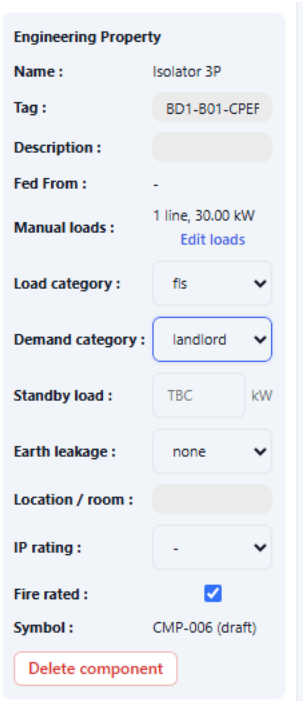
- UPS object is missing;
- Under Earth Leakage Drop Down Menu – include 100mA, ELS+Alarm; 0-300mA ELS+Alarm; 0-500mA ELS+Alarm

- Starter Drop Down Menu is missing;
- For Isolators, the display tag should include the current rating, TP/SP, and equipment fed and the source feeding the isolator;

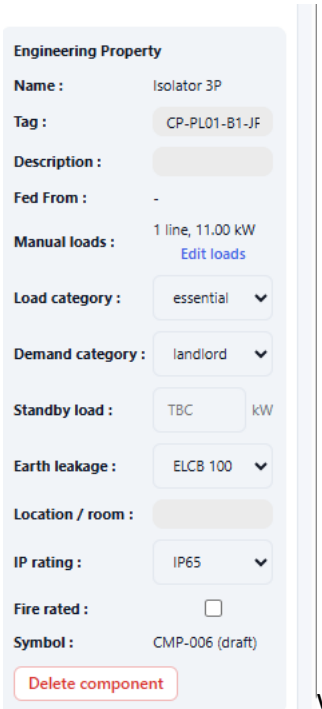
For FLS items, we need to include check boxes to identify if it will run during: 1.Normal mode; 2.power failure mode; 3. Fire Mode – this will be required to assess whether this equipment should be included in the transformer load estimate & generator load estimate (power failure & fire mode);
-

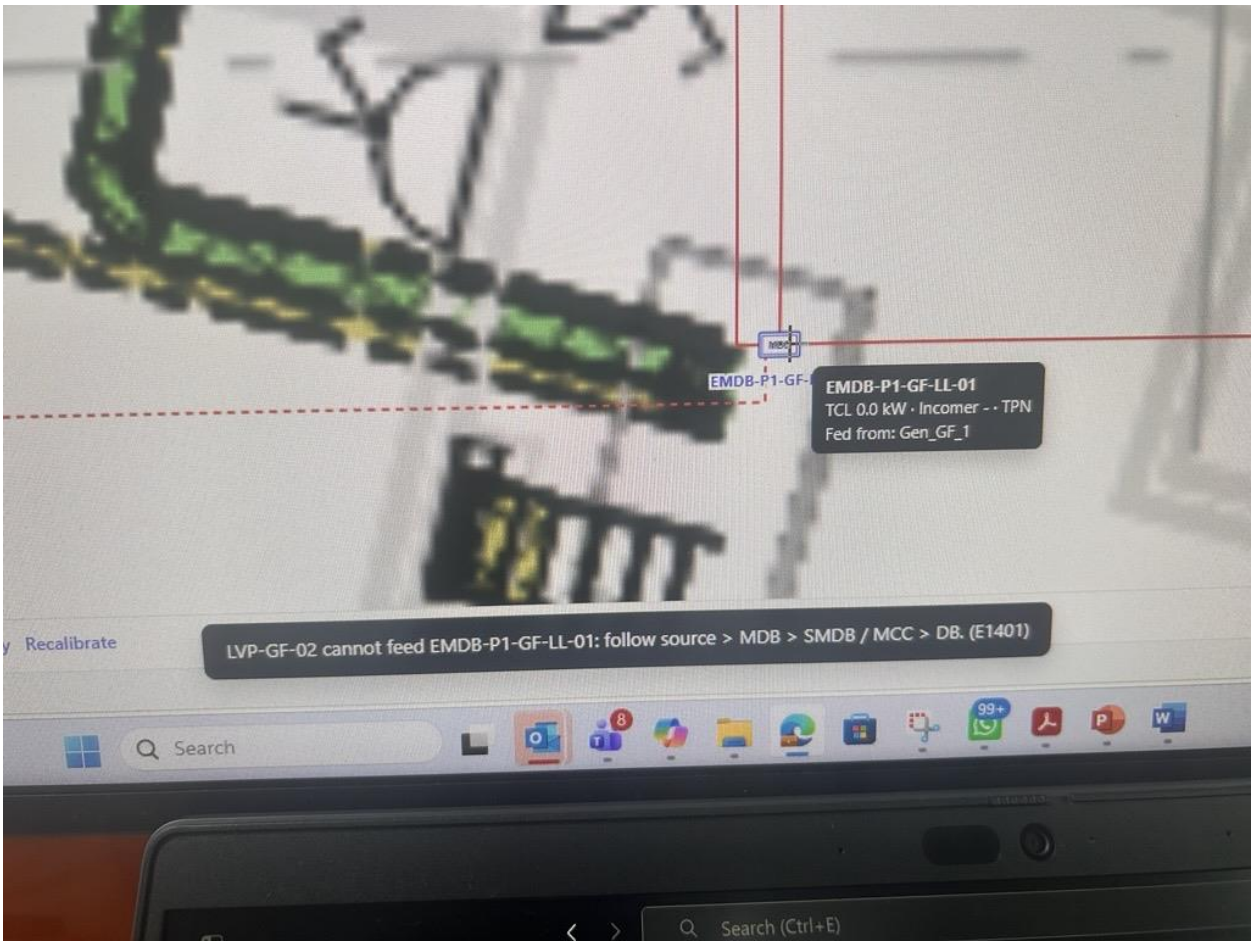
when I choose FLS load – fire rated check box automatically ticks but when I change the load category back to essential it doesn't uncheck;

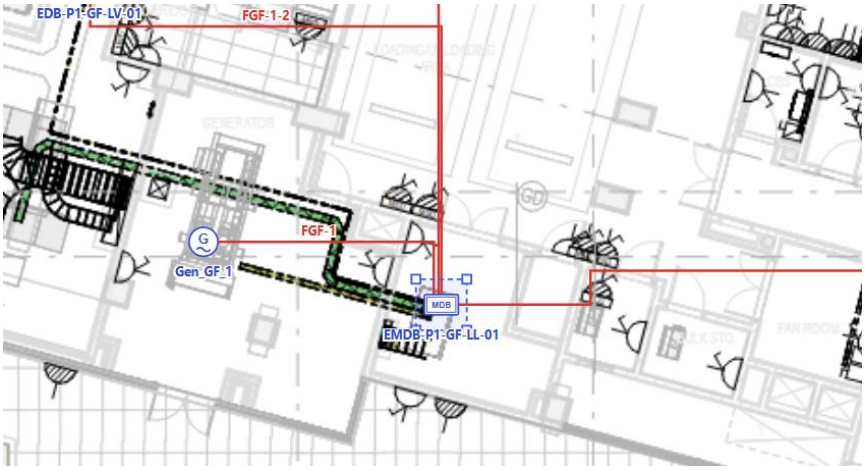
This rule is incorrect; LV Panel can feed EMDB

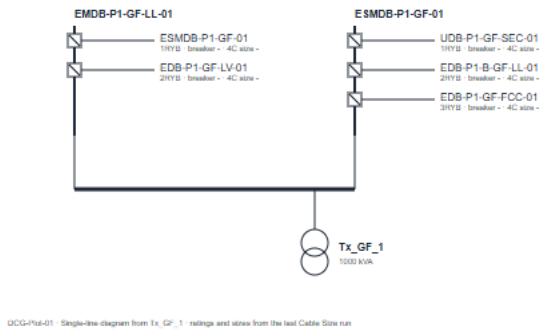
If I want to change this EMDB to ESMDB – the option should be available without deleting all the feeders connecting the upstream & downstream panels/loads;

Schematic representation is incorrect; Tx & Gen both are feeding EMDB -> ESDMD -> EDB & UDB

This view should show the MDB's, EMDB's, ESMDB's for connecting the panels in other floors;
